THE CITY OF REDMOND
PUBLIC WORKS DEPARTMENT

Former Super Rents

Re: Former Super Rent site, 17950 NE Redmond Way, Redmond, WA

Figure 1

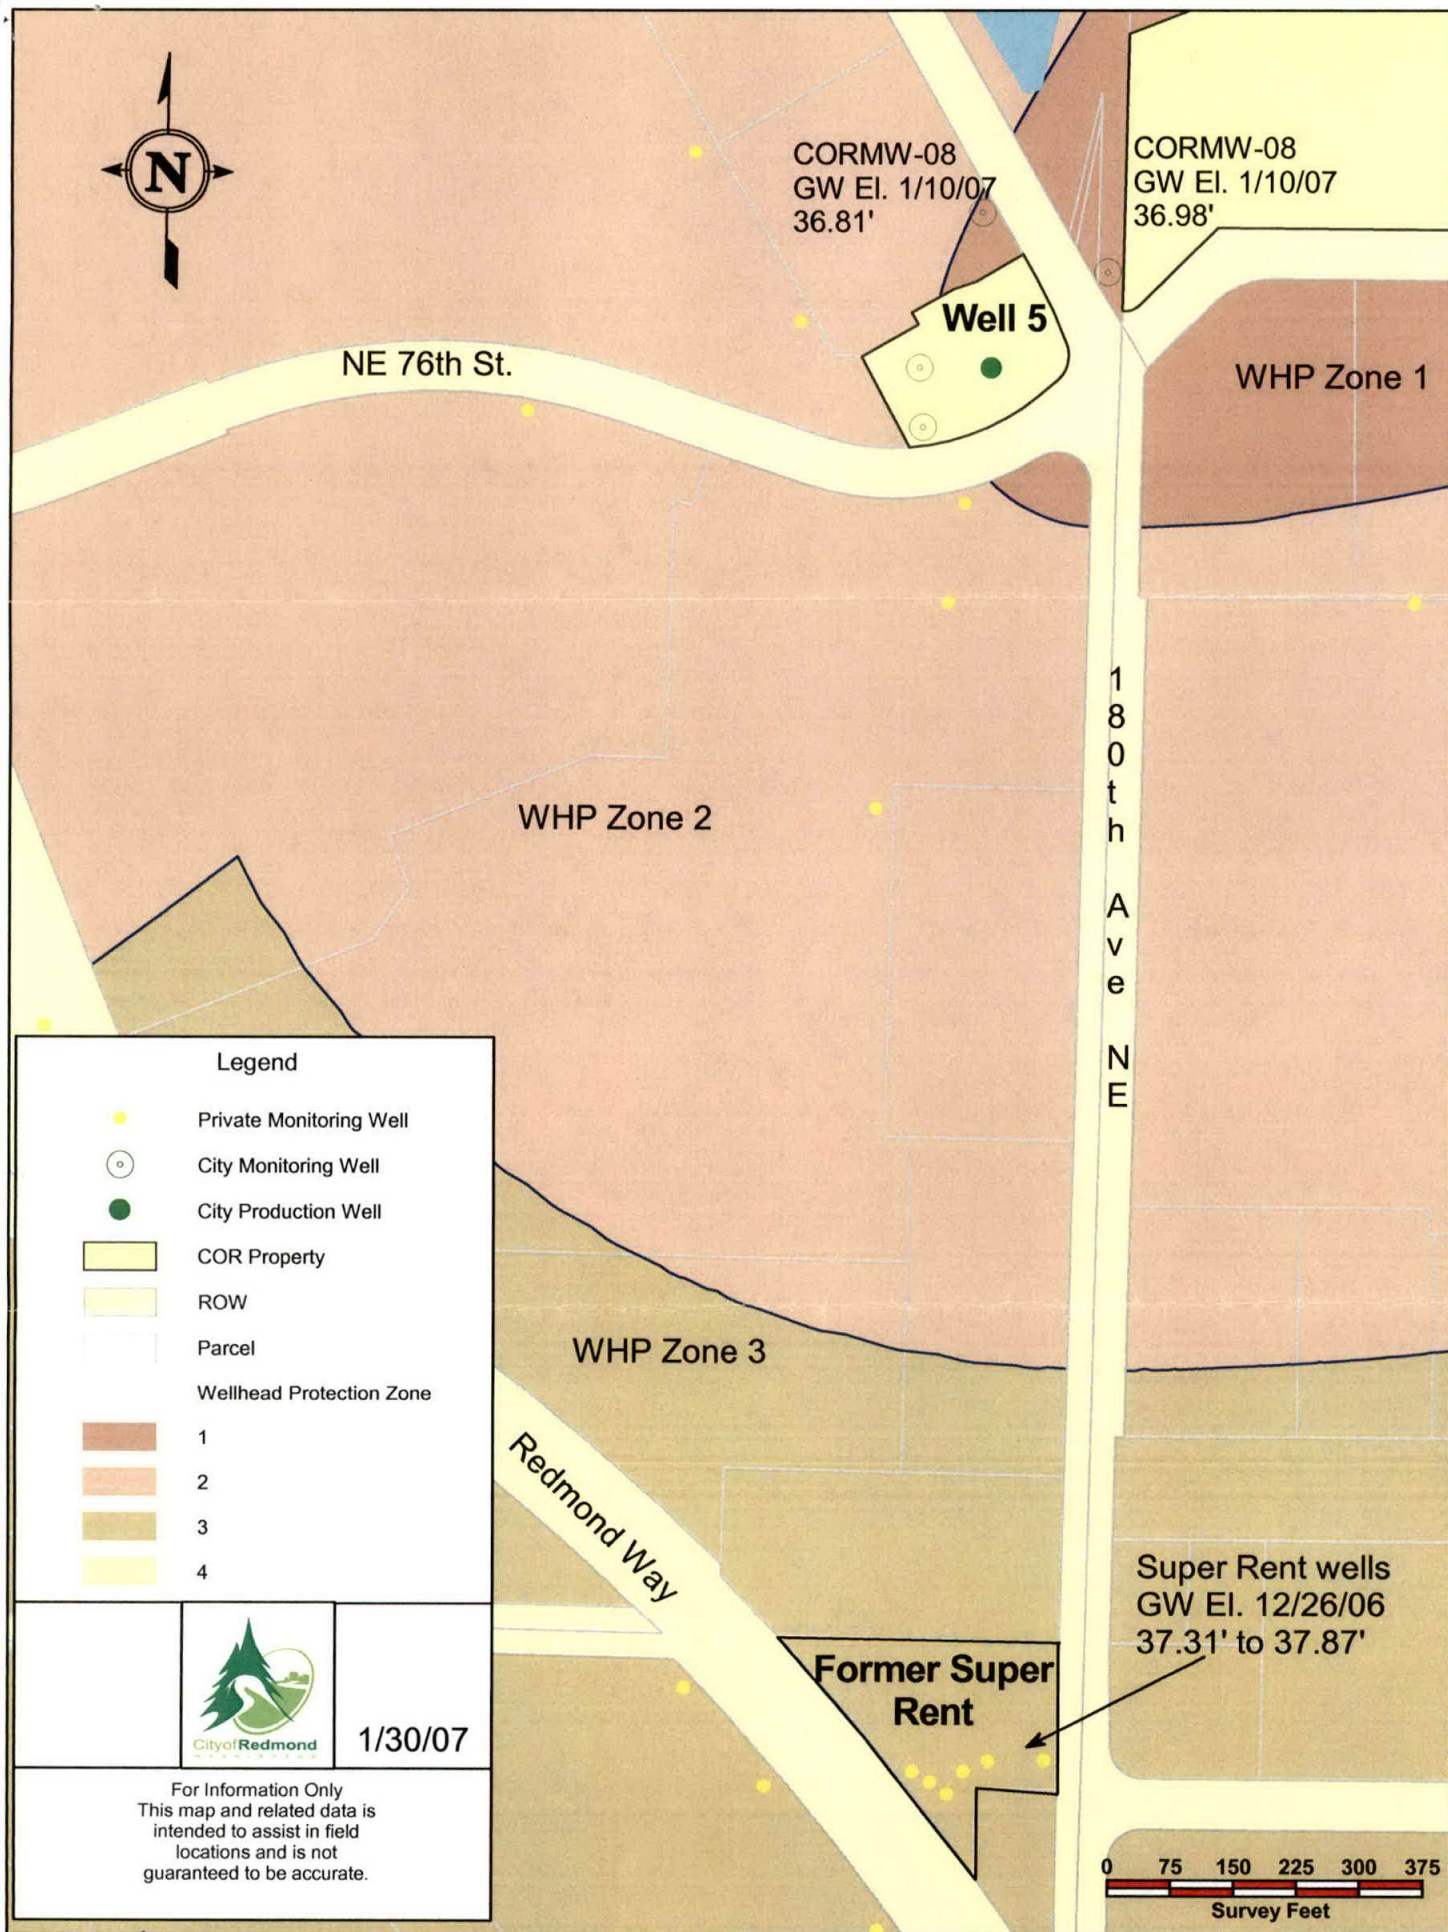
The former Super Rent site is located approximately 1500 feet cross and down gradient from well 5, within Wellhead Protection Zone 3; meaning that groundwater could travel from your site to well 5 in as little as a year (figure 1).

As reported by Aspect Consulting, the groundwater gradient is very flat, and determining a direction of groundwater flow has been difficult at the site. The assumed gradient is toward the west and Aspect has installed down-gradient wells across Hwy 202 in the right of way. Considering the flat gradient and proximity to the City's well 5; it is possible that contamination could migrate from Super Rent toward the north, impact off-site properties and threaten well 5. This becomes an even greater concern when

considering that well 5 is pumping from a similar screened interval, 20' to 29' below ground surface (bgs), as the Super Rent monitoring wells which are screened at depths ranging from 12' to 29' bgs. Further, December 26, 2007 groundwater elevations collected at the Super Rent site show groundwater elevations ranging from 37.31' to 37.87' above MSL, less than one foot higher than the groundwater near the City's well 5 during the same time frame.

The investigation at the Super Rent site appears to have defined the contamination to the east, southwest and west, but not to the north. We urge you to install a well to the north of MW-1, historically one of the most contaminated wells on the site, to demonstrate clean limits to the north and verify that the plume is not migrating toward the City water supply. Additionally, wells MW-1 and MW-2 are screened below the groundwater table during part of the year which may preclude detection of separate phased product during high water table events.

- Install a monitoring well or wells north of the former UST system in order to delineate groundwater impacts to the north. Report the results to the City.
- Sample groundwater quarterly to demonstrate that the dissolved plume is not migrating toward well 5. Report the results to City quarterly.
- Provide the City with your cleanup plan and a timeline for active remediation of the soil and groundwater at the site.
